**SERVICE BULLETIN**

**N° 189-377**

**DATE:** April 28, 2023

**ATA 31 - NR1 AZIMUTH CONNECTIONS RETROMOD**

**Figure 1**

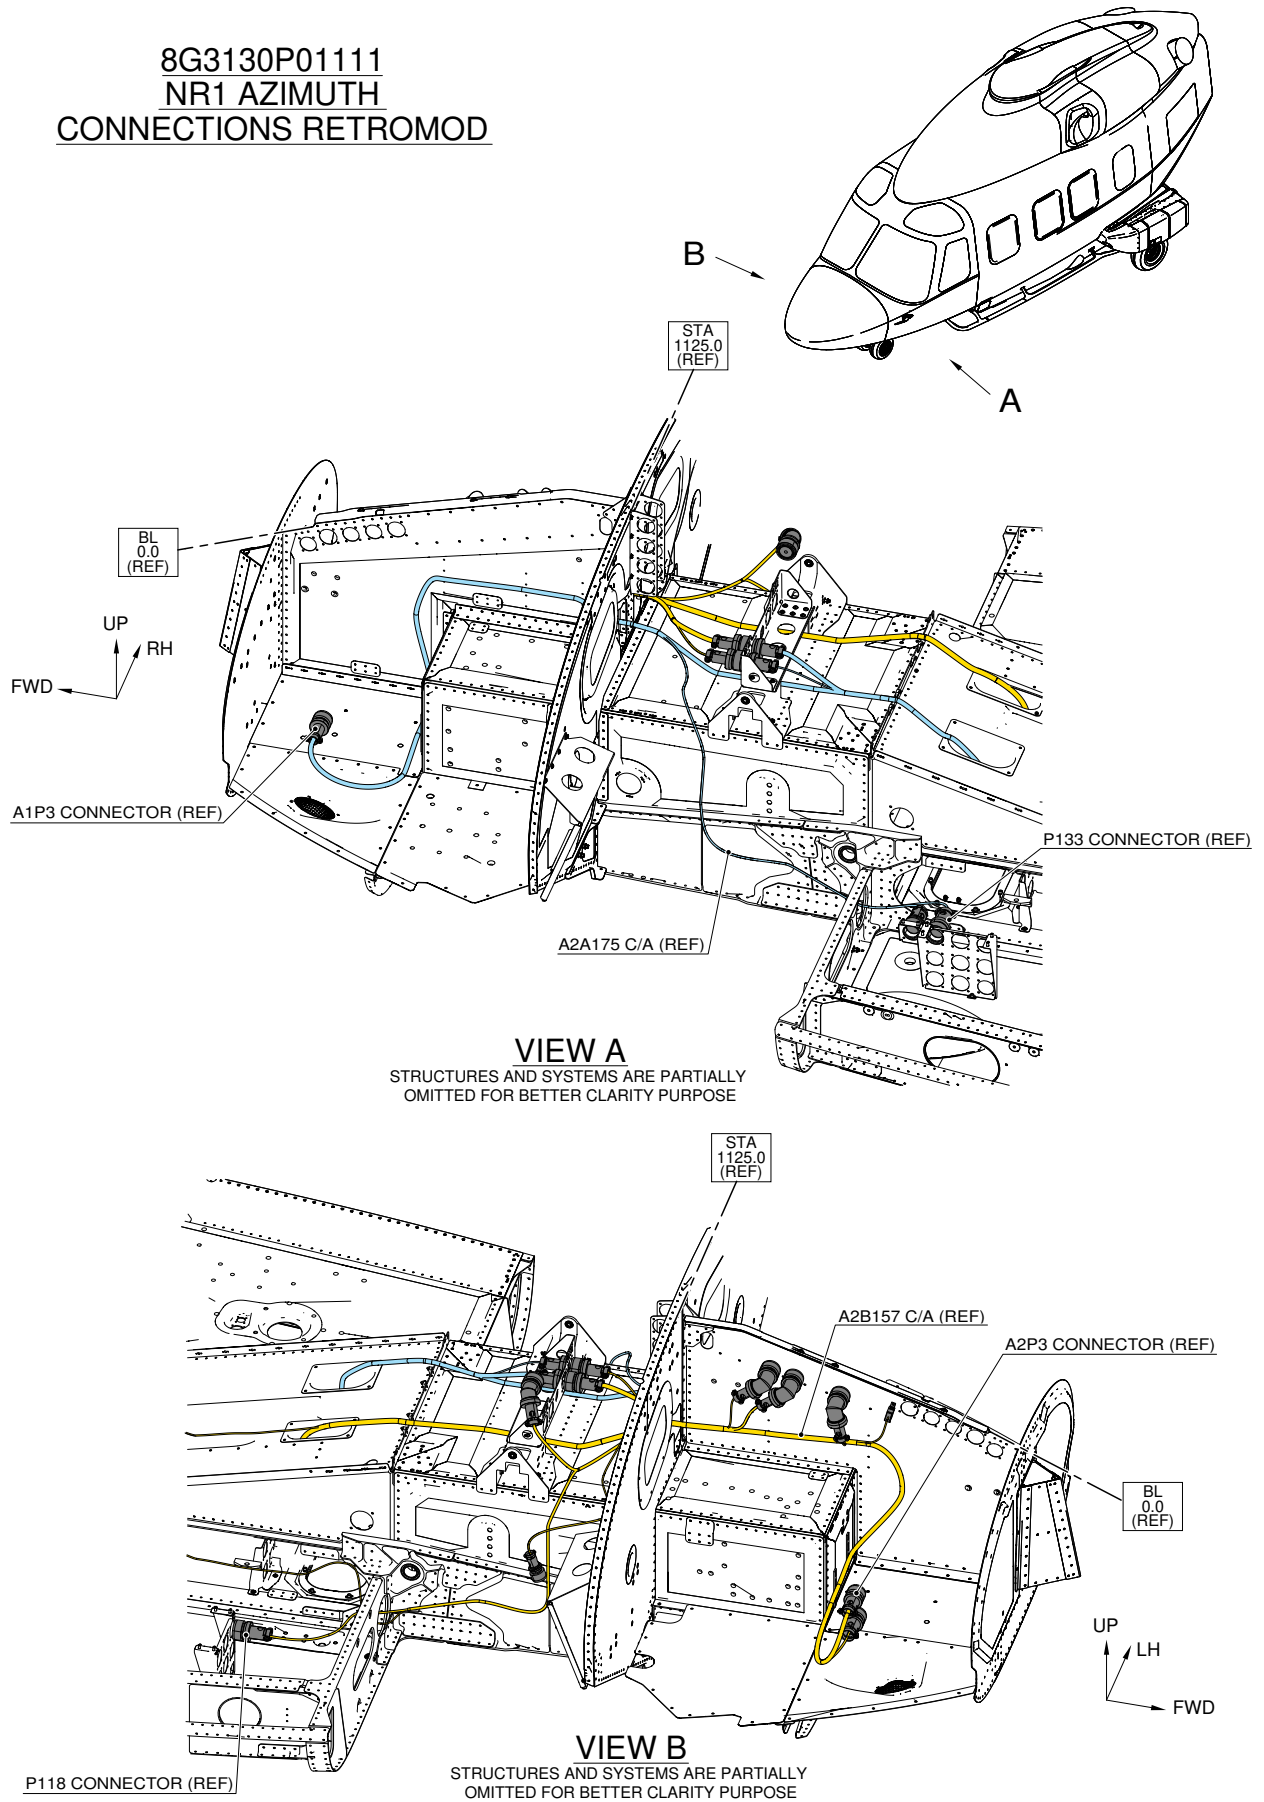
- 2.1 With reference to Figure 1 and Figure 2 wiring diagram, disconnect the wire ID 3130-466 from pin 6 and 7 of the AMMC 1 connector A1P3. Stow by means of n°2 caps P/N A583A2418C.

Splice SP1482 and SP1484 area can be accessed from the cockpit side, under the instrument panel, or from the nose avionic bay side through the bulkhead.

**Figure 2**

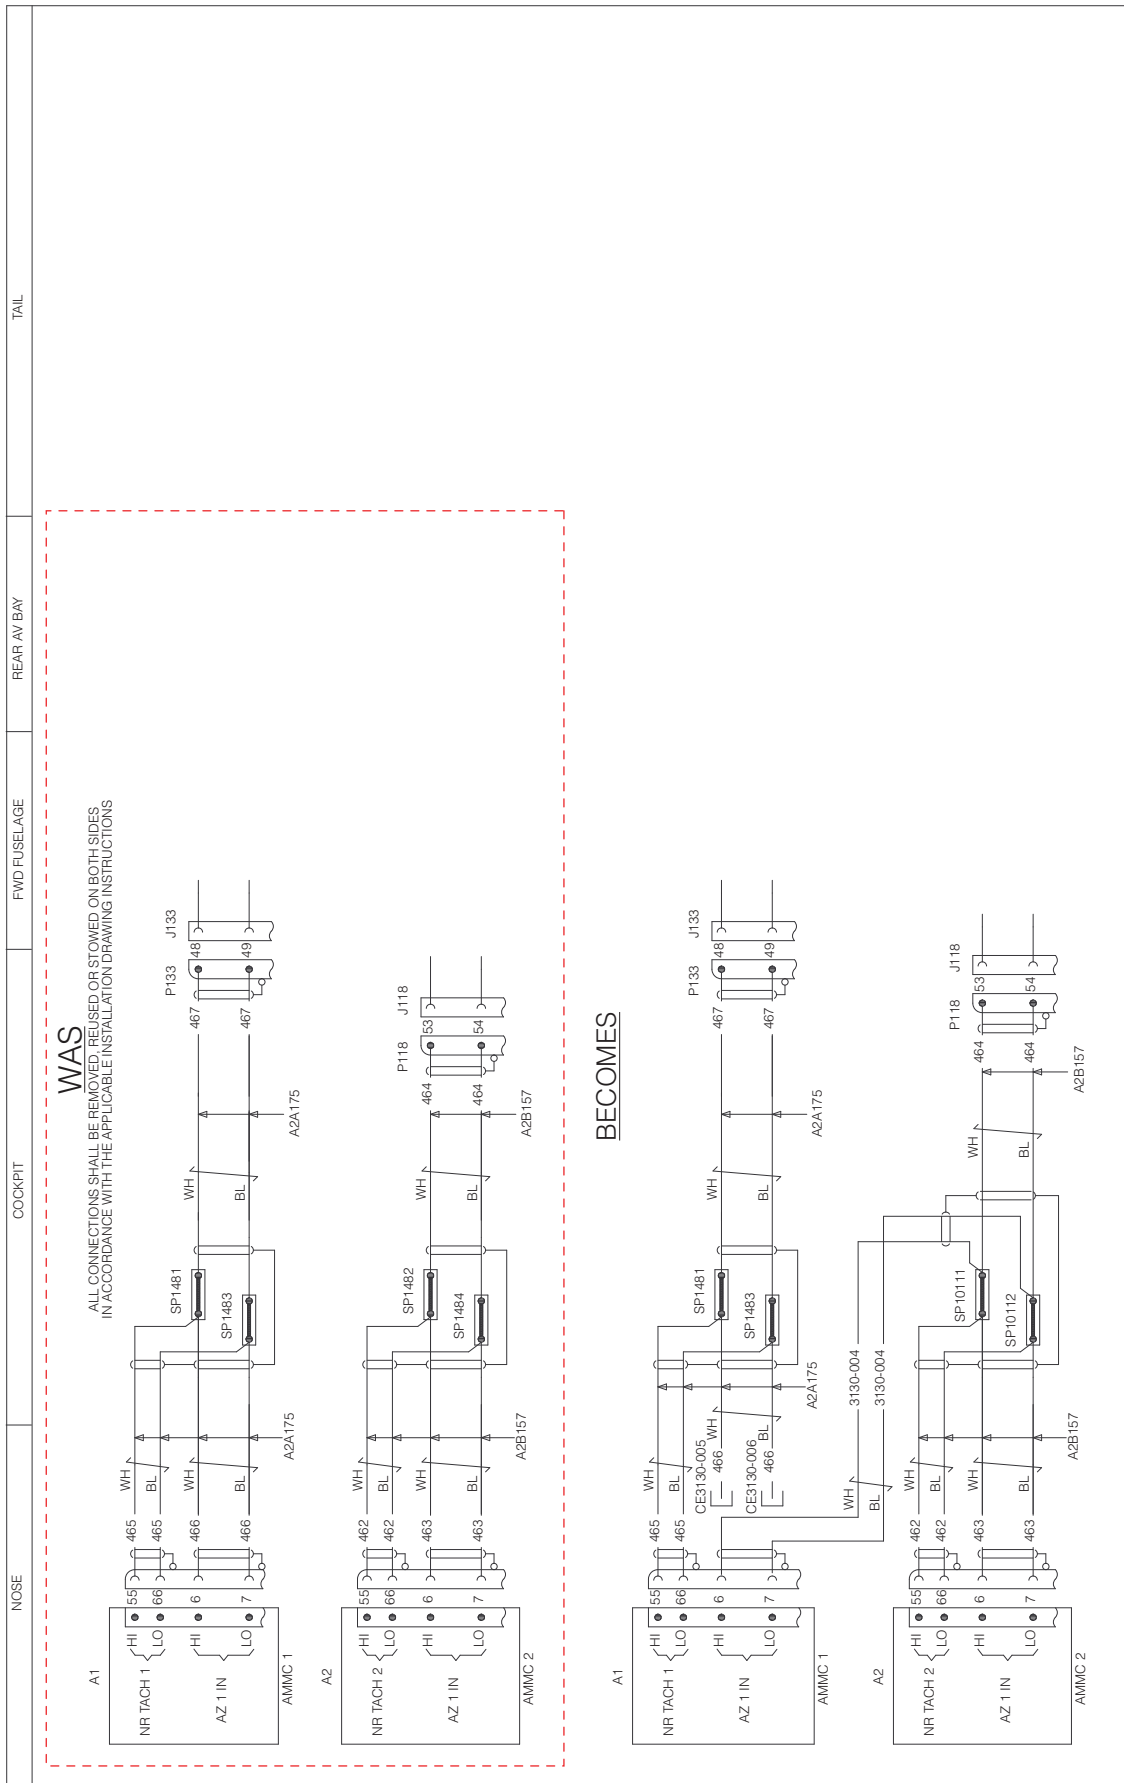
- 2.2 With reference to Figure 2 wiring diagram, cut n°1 wire P/N A561A-T2-24 of adequate length and lay down between AMMC 1 connector A1P3 and existing splices SP1482 and SP1484 following the existing route.
- 2.3 In accordance with AMP DM 89-A-20-10-03-00A-010A-A and with reference to Figure 2 wiring diagram, crimp n°2 electrical contacts P/N M39029/58-360 (AMMC1 connector A1P3 side) by means of proper crimping tool.

- 2.4 In accordance with AMP DM 89-A-20-10-06-04A-720A-A and with reference to Figure 2 wiring diagram, mark wire as 3130-004 by means of marker sleeve.
- 2.5 With reference to Figure 2 wiring diagram, remove n°2 existing splices SP1482 and SP1484.
- 2.6 With reference to Figure 1 and Figure 2 wiring diagram, perform the electrical connections of wire ID 3130-004 between pin 6 and 7 of AMMC 1 connector A1P3, the splice SP10111 (P/N M81824/1-1) and the splice SP10112 (P/N M81824/1-1).
3. In accordance with AMP DM 89-A-06-41-00-00A-010A-A, reinstall all external panels, internal panels and internal liners previously removed.
4. Return the helicopter to flight configuration and record for compliance with this Service Bulletin on the helicopter logbook.
5. Gain access to My Communications section on Leonardo WebPortal and compile the "Service Bulletin Application Communication".
